**Addendum No. 001**

**Subject: 2020 Classroom Modernizations**  
**SDP Contract Numbers: B-028 C of 19/20 & B-030 C of 19/20**

**Location: Overbrook Educational Center**  
**6722 Lansdowne Ave, Philadelphia PA 19151**

**This Addendum, dated March 6, 2020, shall modify and become part of the Contract Documents for the work of this project. Any items not mentioned herein, or affected by, shall be performed strictly in accordance with the original documents.**

1 ELECTRICAL FIRST FLOOR LIGHTING PLAN  
E1.1 1/8" = 1'-0"

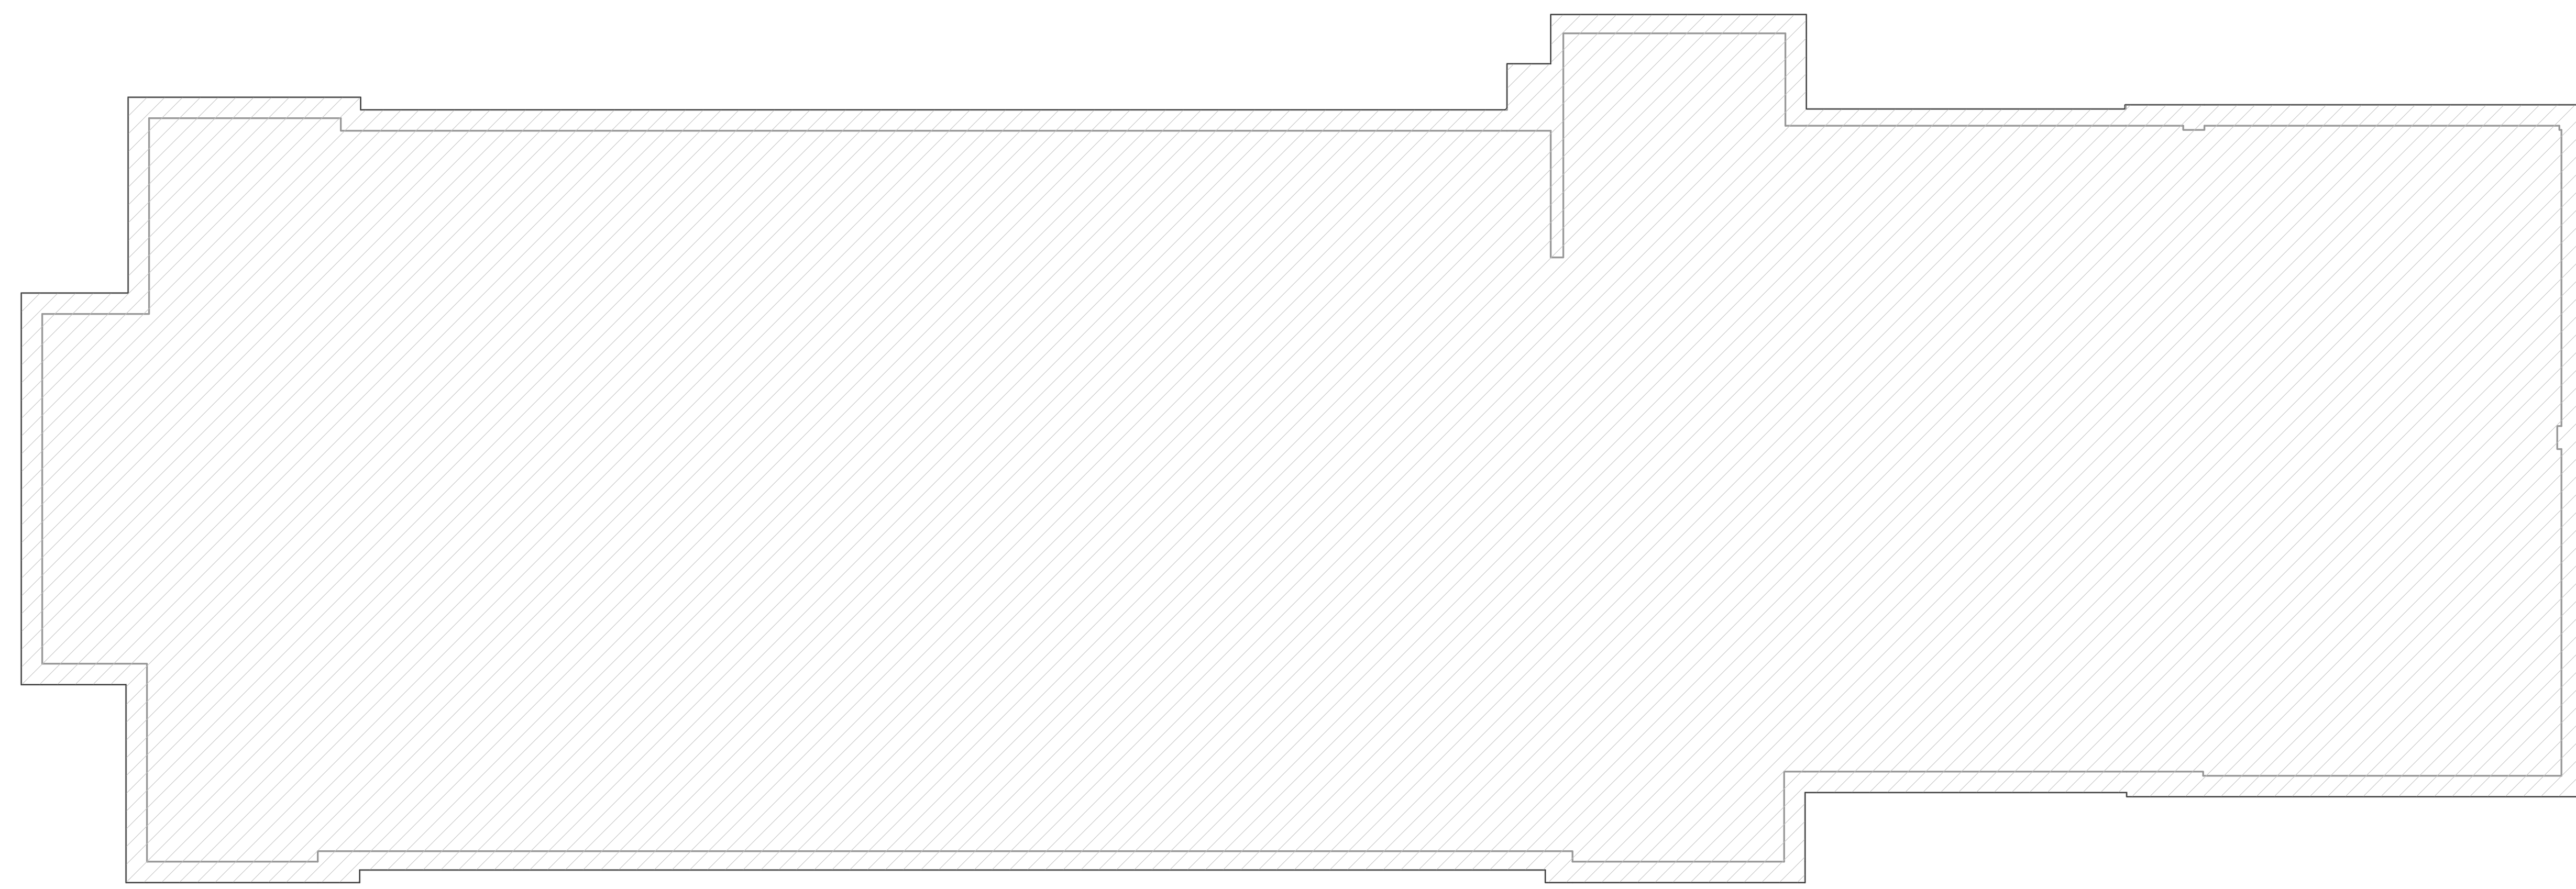
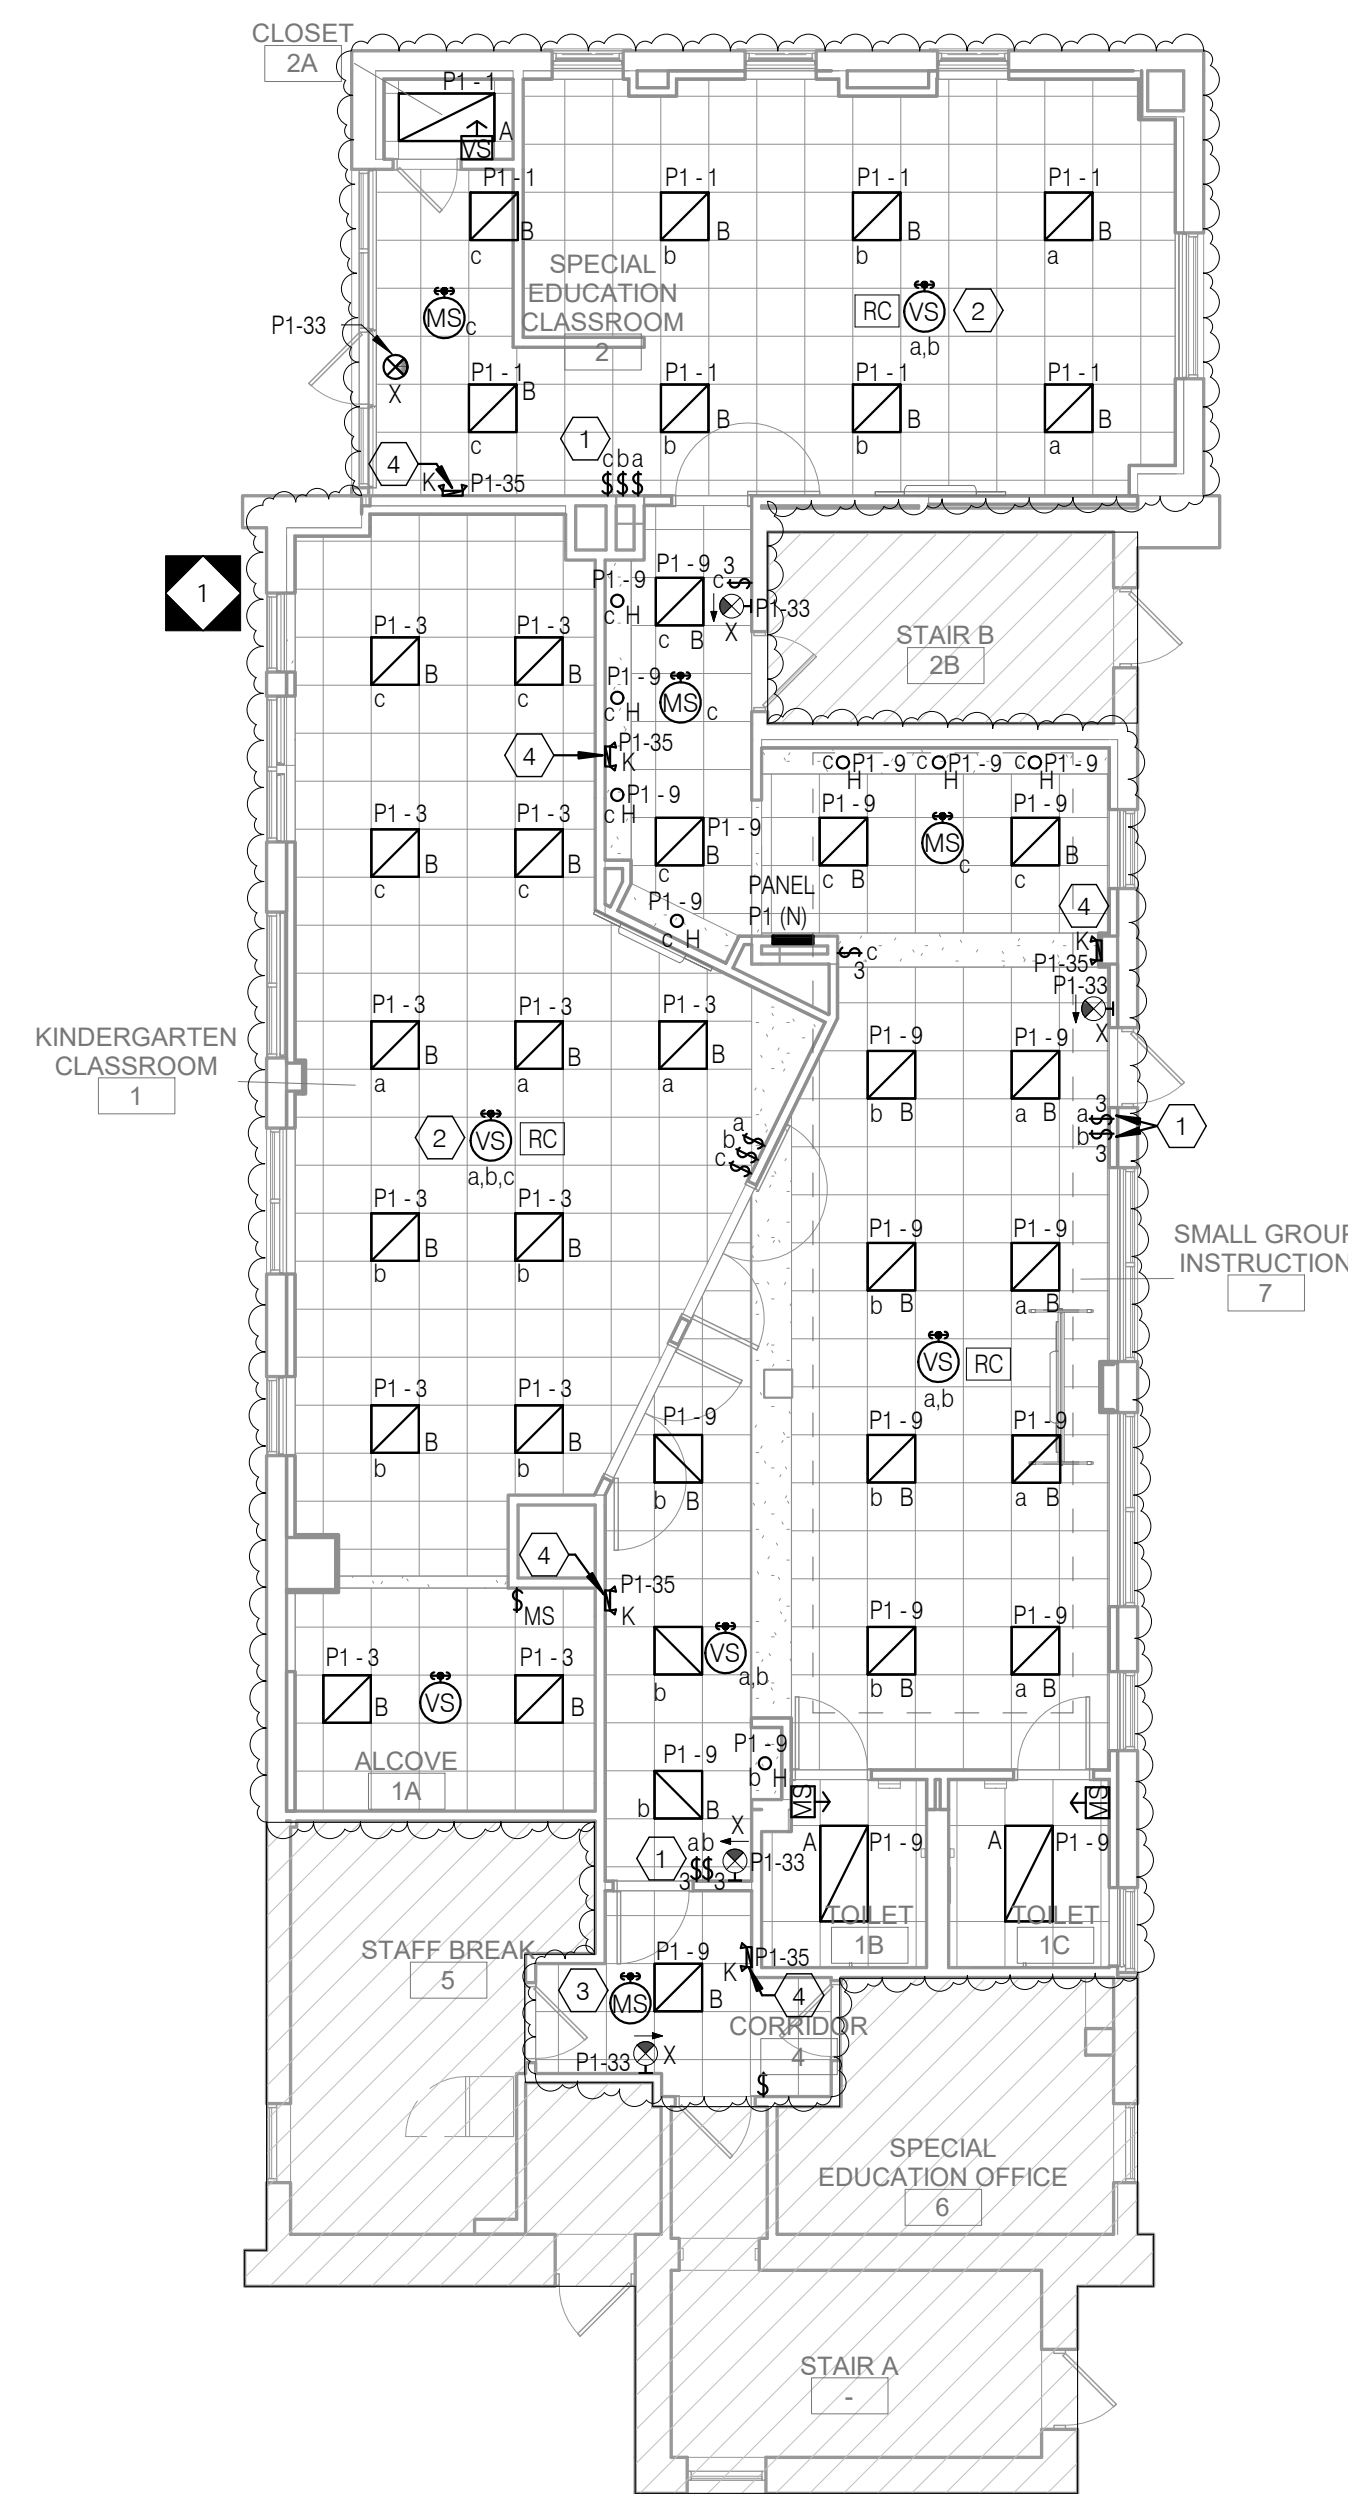
1. REVISE lighting layout and zones as indicated on the drawings.

DRAWING NO.  
**E1.1**

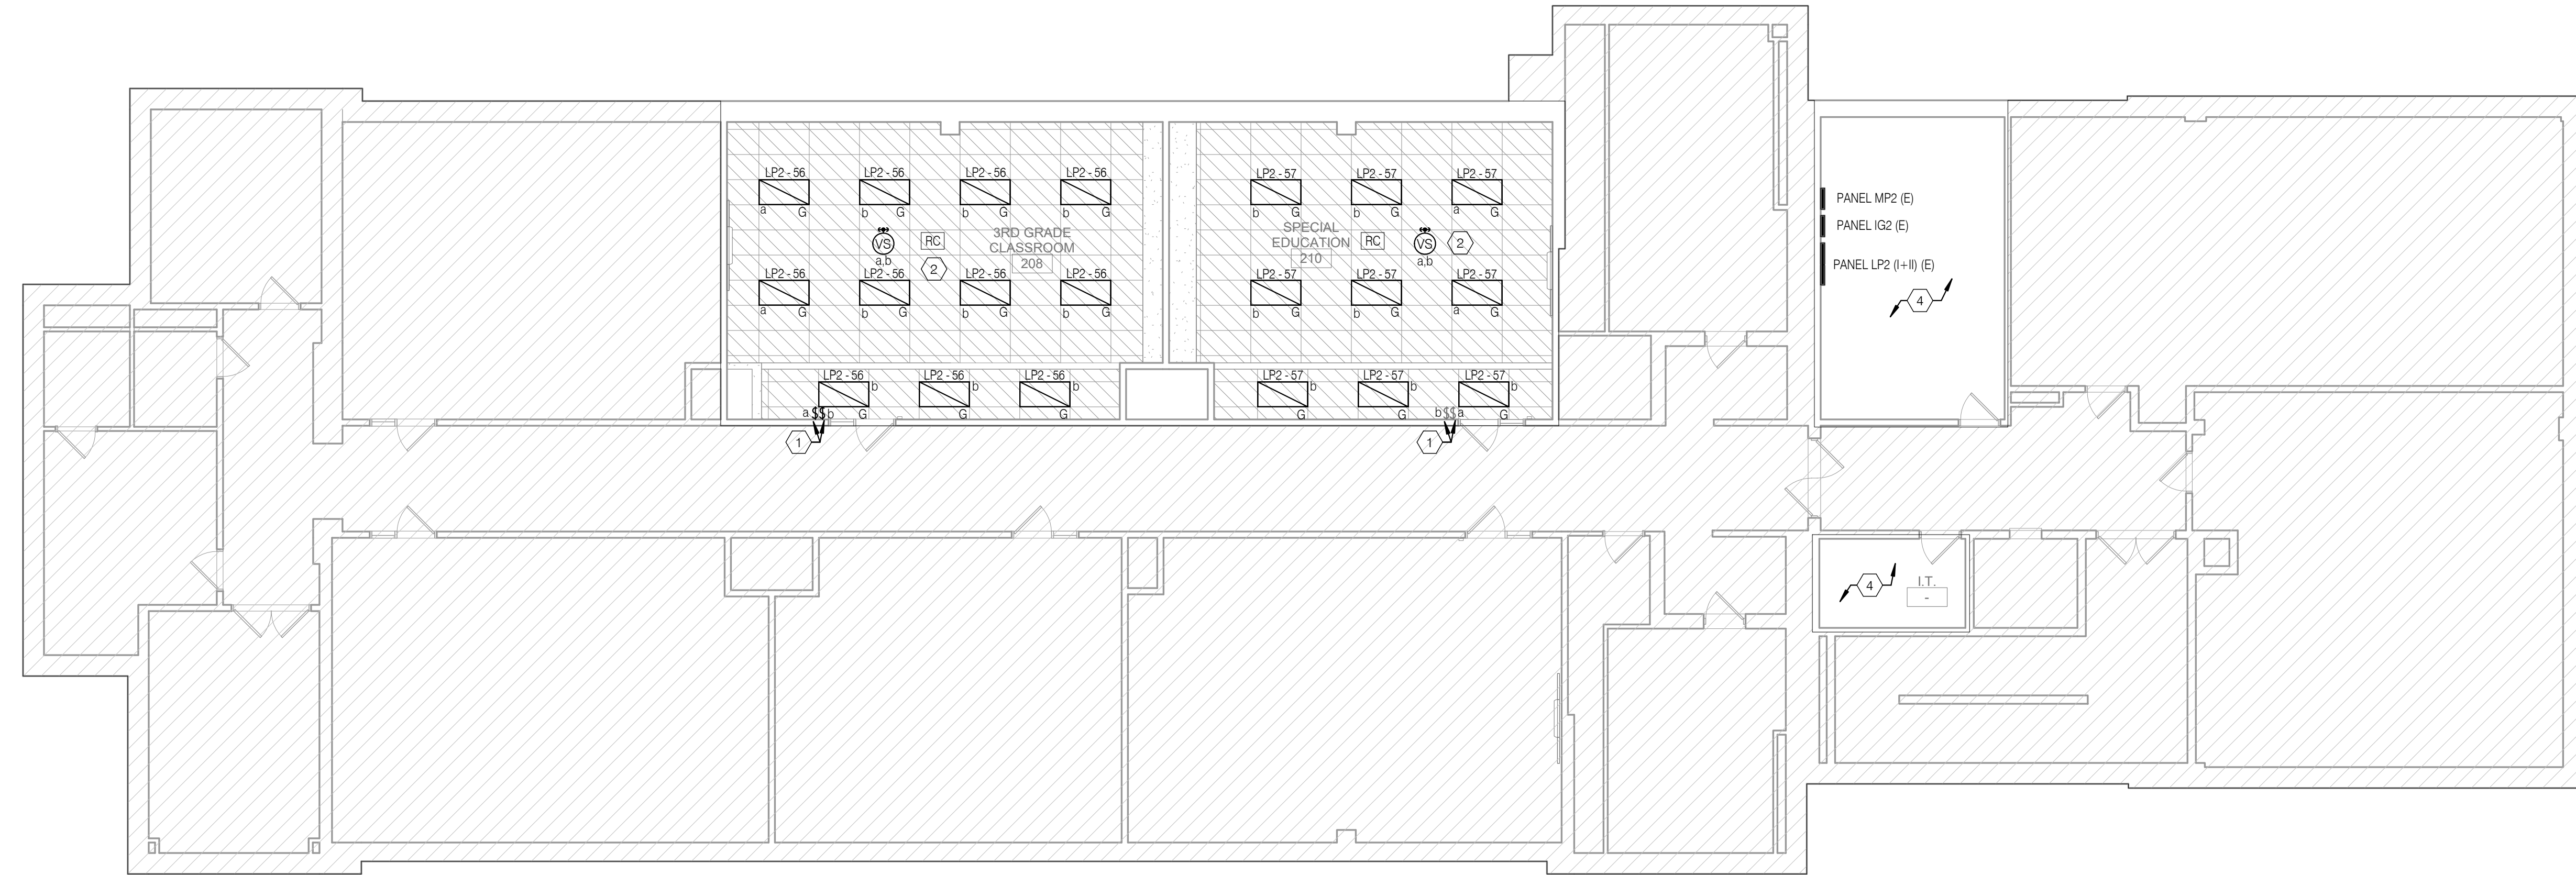
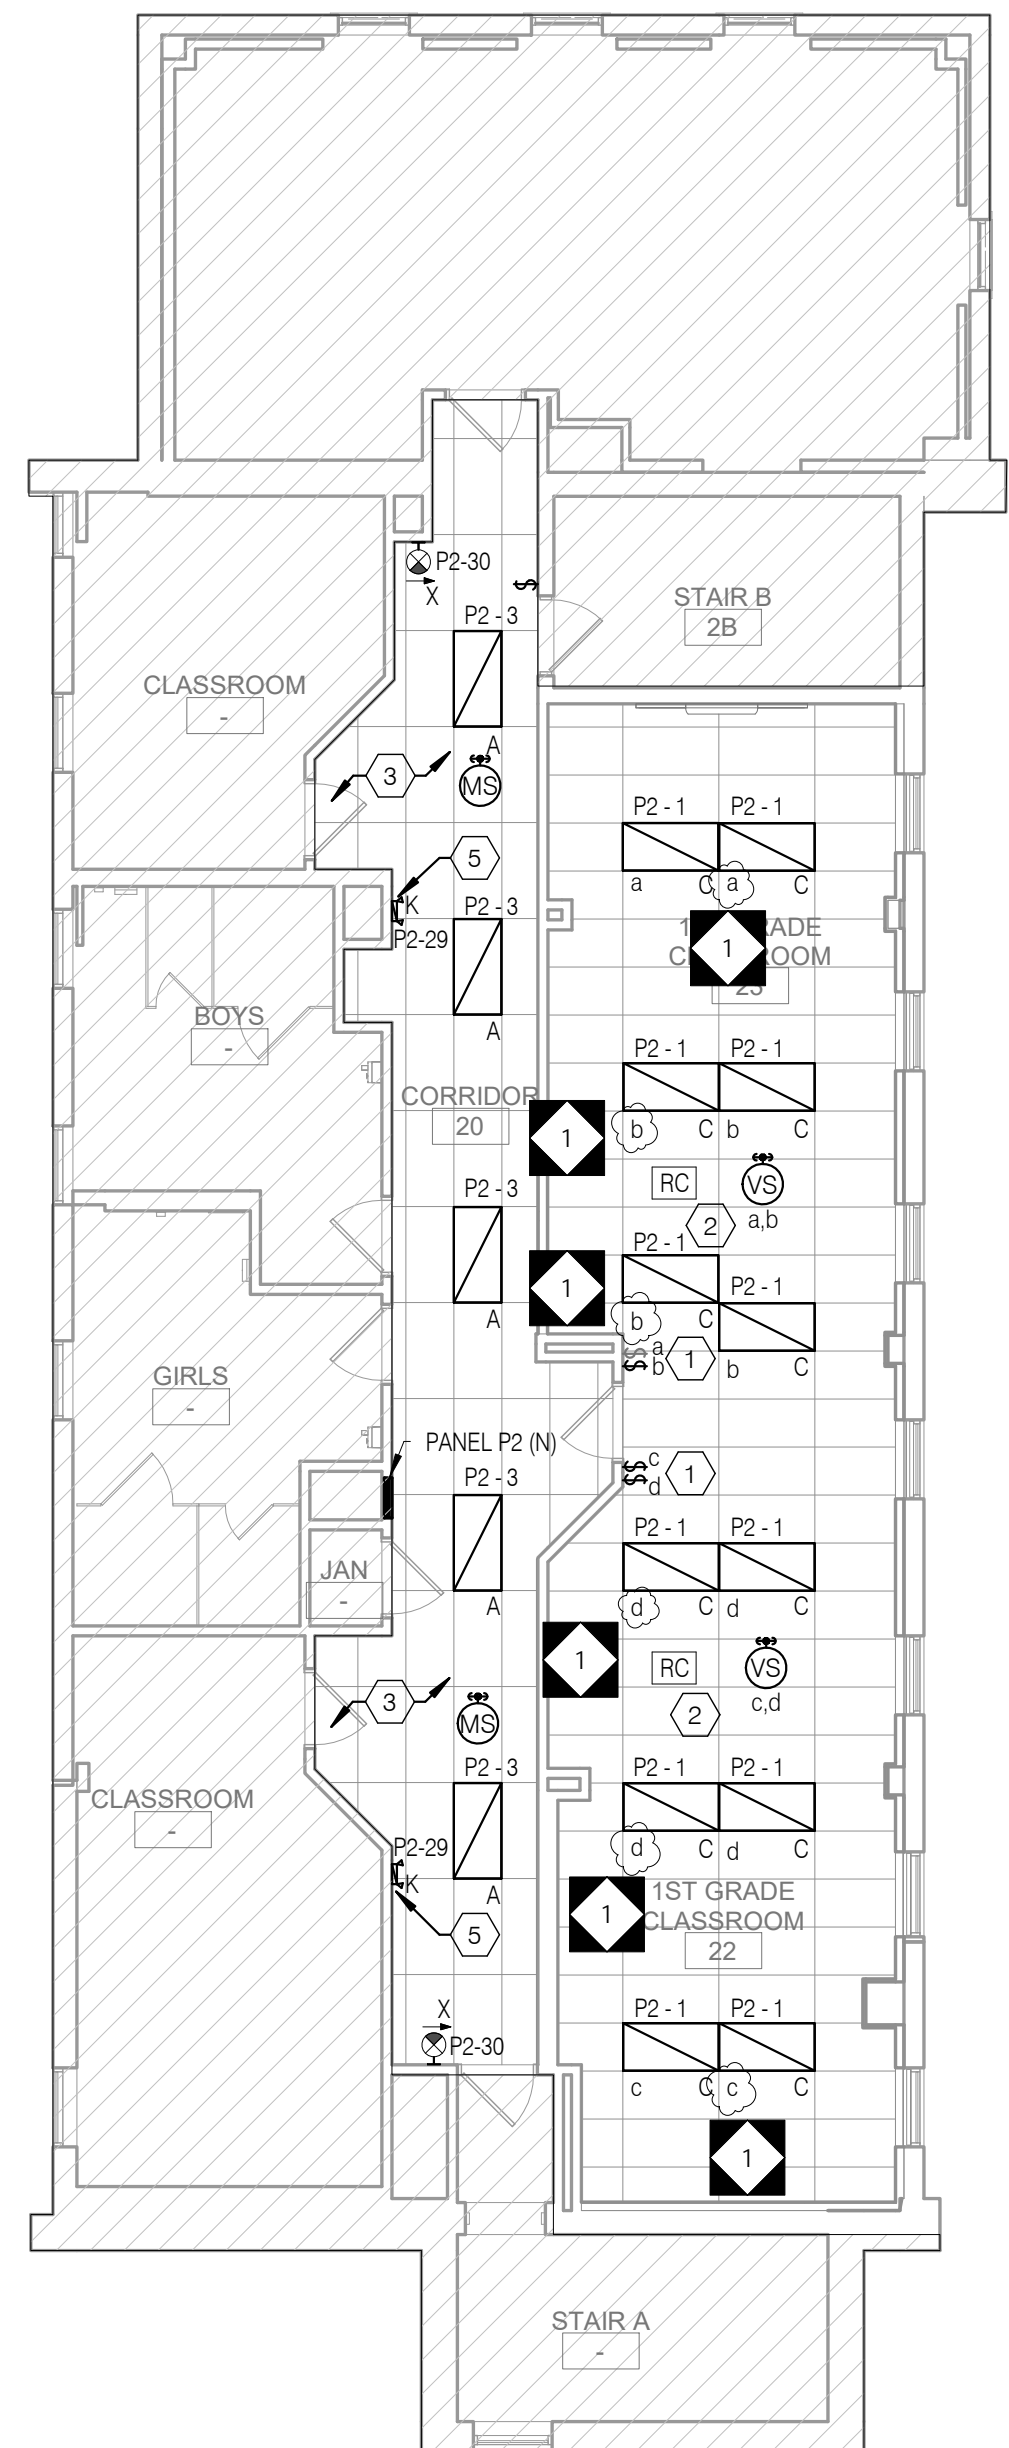
1. REVISE lighting zones as indicated on the drawings.
2. REVISE lighting plan per new 2x2 grid.
3. ADD downlight fixtures to bulkheads.
